**STAFF RECOMMENDATION**

**1501 Fatherland Street**

**August 18, 2021**

**Application:** New Construction – Infill & Outbuilding

Figure 5. Site plan

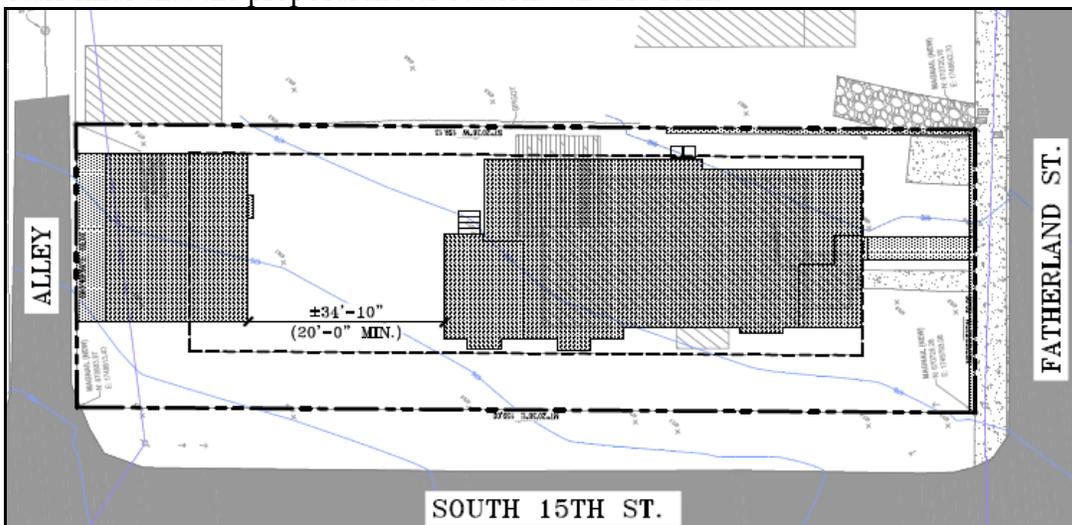
Siting, Setback, Orientation and Rhythm of Spacing: The infill is sited with the primary structure facing the street. (Figure 5) The garage is a secondary structure that is subordinate in size and located in the rear yard, along the alley. This siting is appropriate to the historic neighborhood. A concrete walkway is provided from the house to the sidewalk along Fatherland Street. The HVAC location was indicated along the side elevation, far back from the front of the house.

The side setbacks will be five feet (5') on the interior side and a minimum of ten feet (10') on the street side, which meets base zoning. The front setback will be twenty feet (20'), which will align with the historic house to the right. On the rear, the house will be more than sixty-five feet (65') from the rear property line and more than thirty-four feet (34') from the garage. The project meets all setback requirements.

Staff finds that the project meets section V.C.

Figure 6. Proposed garage as seen from house. Note slope.

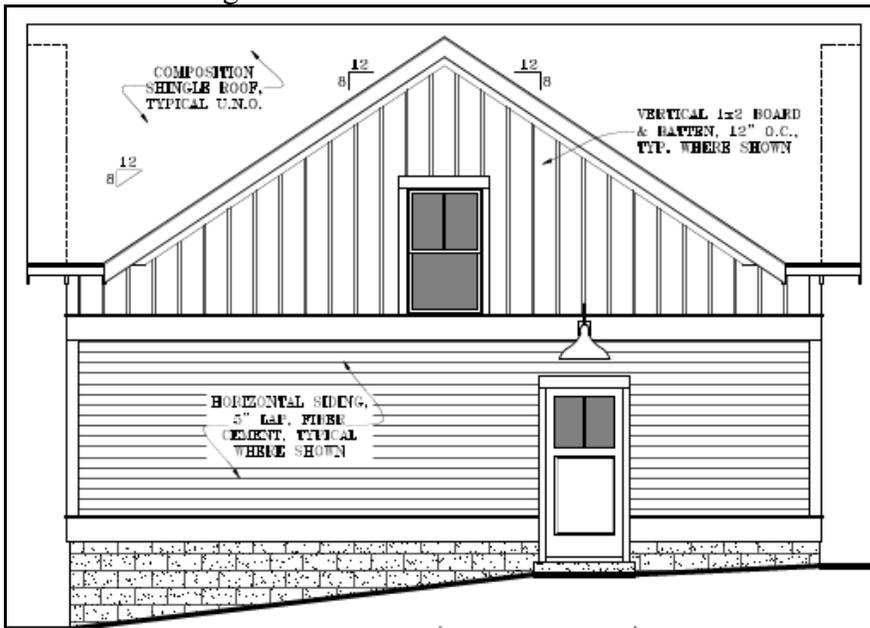
Outbuilding: The applicant is proposing a rear three car garage. The outbuilding will not contain a dwelling unit.

Because this is a corner lot, the ridge height of the outbuilding is limited to the ridge height of the primary structure. This house has a twenty-five foot (25') ridge, so the proposed outbuilding height -which ranges from about twenty-one feet, six inches to about twenty-four feet (21'6"-24') from grade - is appropriate. Staff finds that the outbuilding's massing and form to meet Section VII.B. of the Part I and the Lockeland Springs-East End chapter of Part II. of the consolidated design guidelines for the turn-of-the-century neighborhood conservation zoning overlays.
